MEMORANDUM

Subject: **Z178-358 SMAA Rezoning—Frederick Square Alley**
PK#2386-16.242

The following memorandum is a supplement to the original Traffic Impact Analysis (TIA) for the proposed SMAA/LPC development located between Douglas Avenue and Lomo Alto Street, north of Colgate Avenue in Dallas, Texas. The project will contain new office, residential, and restaurant uses with structured parking. The structured parking will also provide dedicated and shared parking spaces for the existing church uses to remain on the site. The property is now under consideration for rezoning.

Site Generated Trip Distribution - Inbound

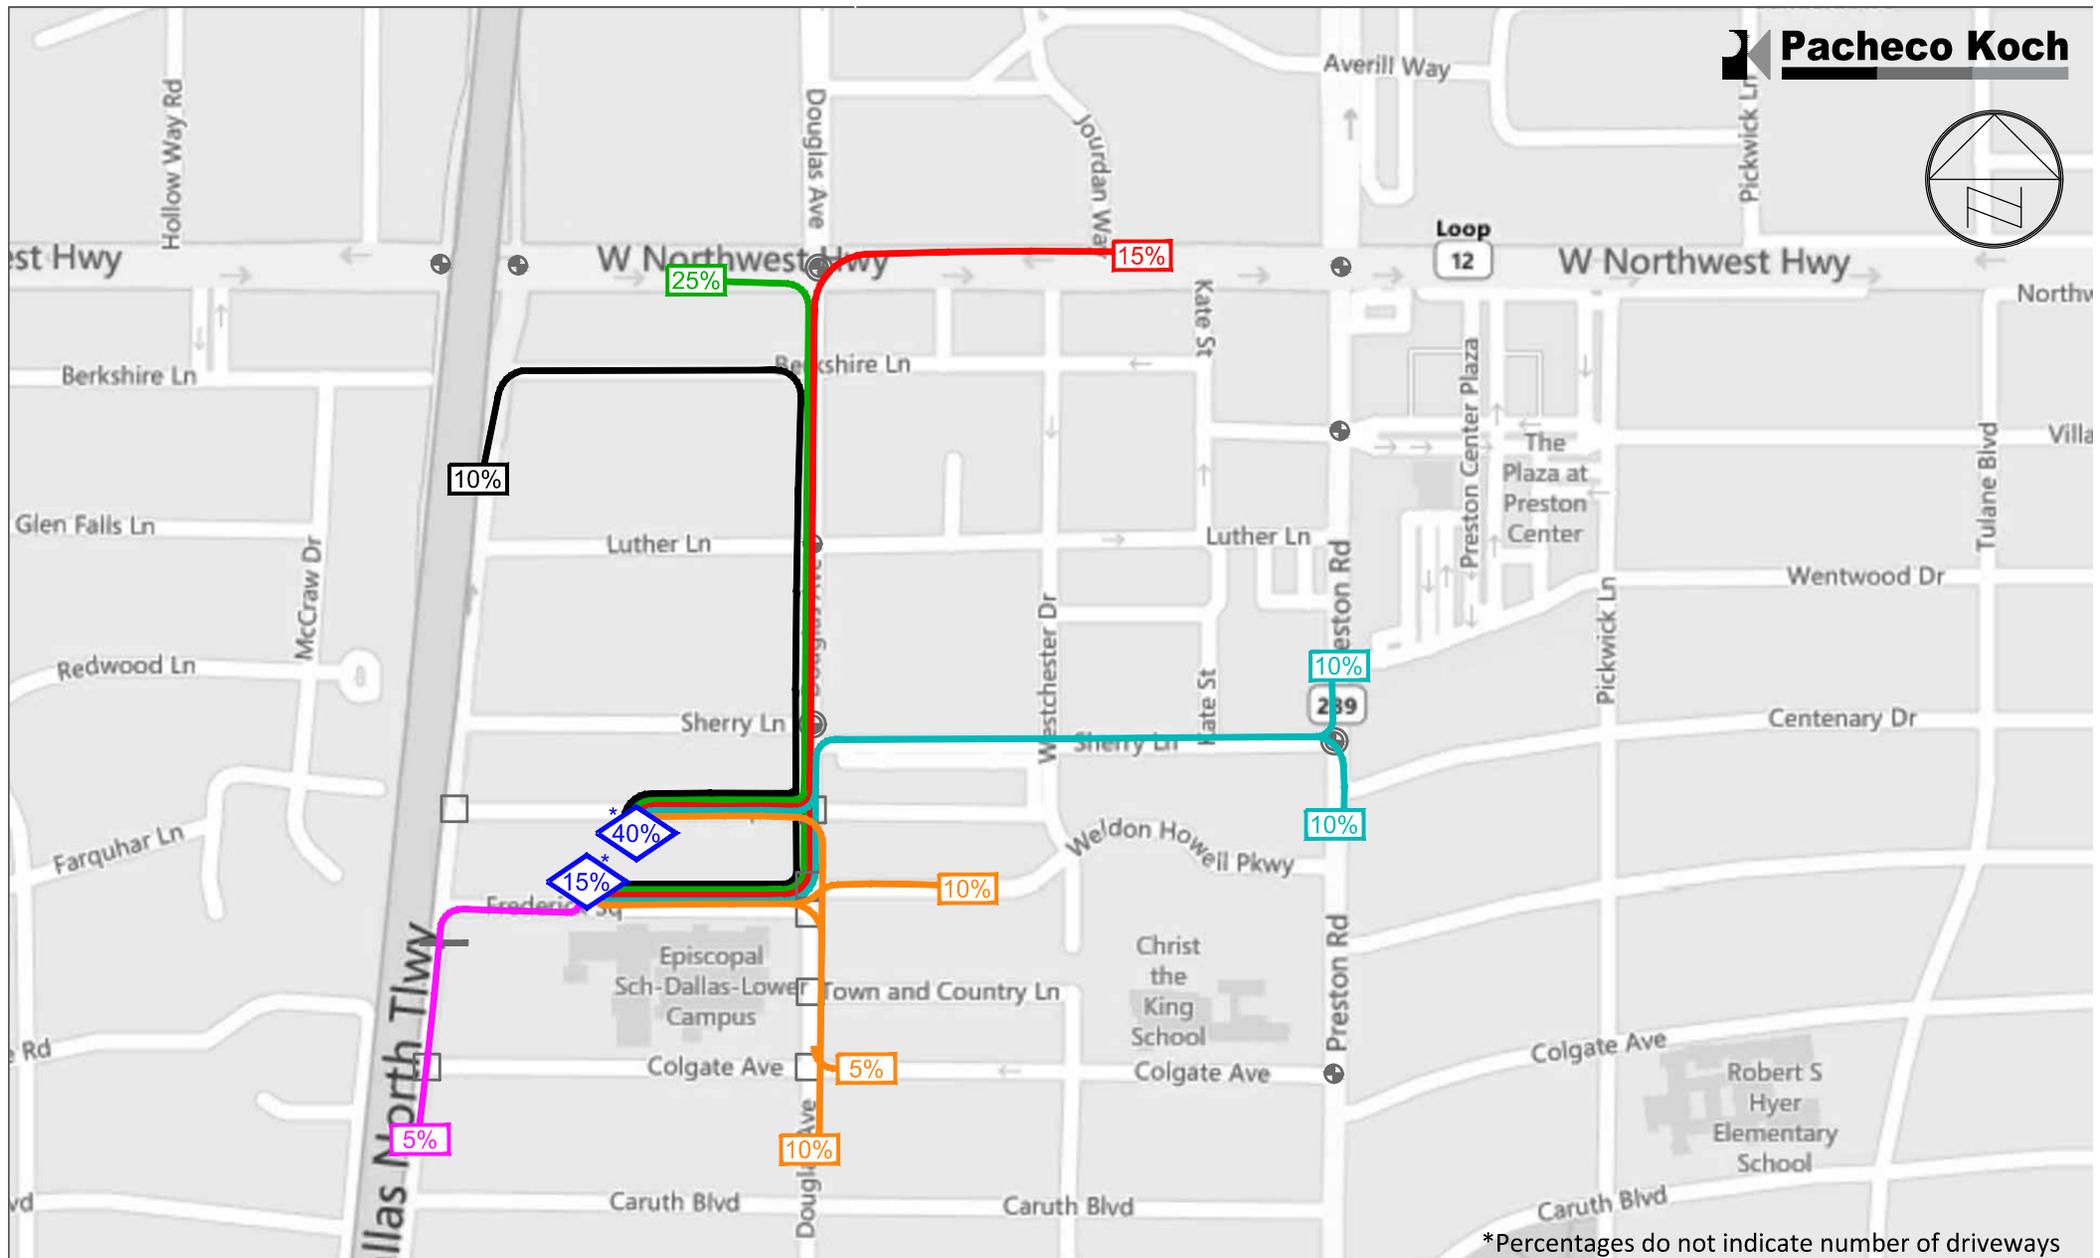
Staff is unable to support the amount of development impact on an improved, standard, public alley. Instead, a recommendation is made to address the root of the problem—the amount of site generated traffic on the alley.

Staff recommends reducing the number of proposed access points to no more than one egress-only driveway for Subdistrict II, in addition to any loading spaces or docks already shown on the proposed development plan. A supplemental technical memorandum evaluating this condition may be submitted in lieu of a full revision to the traffic impact analysis, at the applicant's discretion.

Site access to the project is proposed to be provided on Frederick Square and on a parallel, internal access drive. In the original TIA, the majority (>85%) of the site traffic generated by the new uses was assumed to access the site via Frederick Square in accordance with the design intent of maintaining a pedestrian-friendly environment between the church uses and the new development. This “plaza” area will accommodate occasional outdoor church-sponsored activities, such as a weekly Farmer’s Market (seasonal). During such times, it would be intended for the internal access drive to be closed to through traffic. However, as the site design has evolved, the importance of distributing the site traffic to multiple access points has become known, thus the site access from the internal access drive has become more prominent. It is currently estimated that approximately half of the site traffic will enter and exit the site via Frederick Square and half via the internal access drive (see attached, revised trip distribution exhibits). The resulting daily volume of new, site-generated traffic on Frederick Square will be approximately 1,879 vehicle per day; 128 vehicles during the AM peak hour; and, 173 vehicles per hour during the PM peak hour (calculations also attached).

With regard to the number of access points on the alley, the Designers and Developers prefer to have a minimum of two (both ingress and egress) serving Zone II in order to separate office traffic and residential traffic. This separation is desirable to control access

Another consideration is that, during events on the plaza (typically during evenings and weekends, e.g., the Farmers Market), temporary closure of the internal access drive may garage access to/from the internal access drive. Therefore, maintaining vehicular ingress and egress for site on Frederick Square is essential. The Developer will agree, however, to reduce the number of garage access points from three to two (excluding loading docks).
